Marine Licence Consultation for Consultation under Section 36 of the Electricity Act 1989, the Marine (Scotland) Act 2010 and Marine and Coastal Access Act 2009 for the Erection of Offshore Wind Farm and Associated Infrastructure at Muir Mhòr Offshore Wind Farm, Peterhead

As we are yet to receive any application regarding terrestrial works in connection with this overall project, our response is based purely on the submission which primarily relates to offshore works. The offshore EIAR has been assessed and the comments listed below reflect the key areas of interest for Aberdeenshire Council.

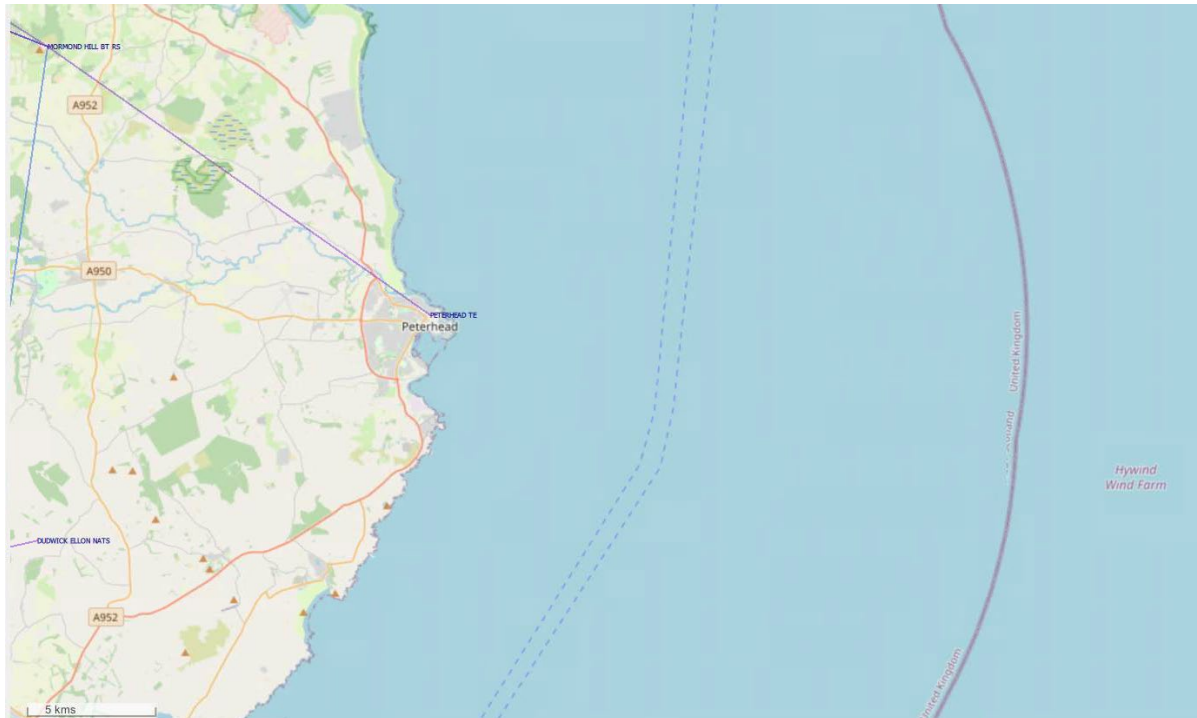
The conclusion is that the proposed location of the Muir Mhór Offshore Wind Farm should not cause interference to BT's current and presently planned radio network.

BT requires 100m minimum clearance from any structure to the radio link path. If the proposed locations change, please let us know and we can reassess this for you.
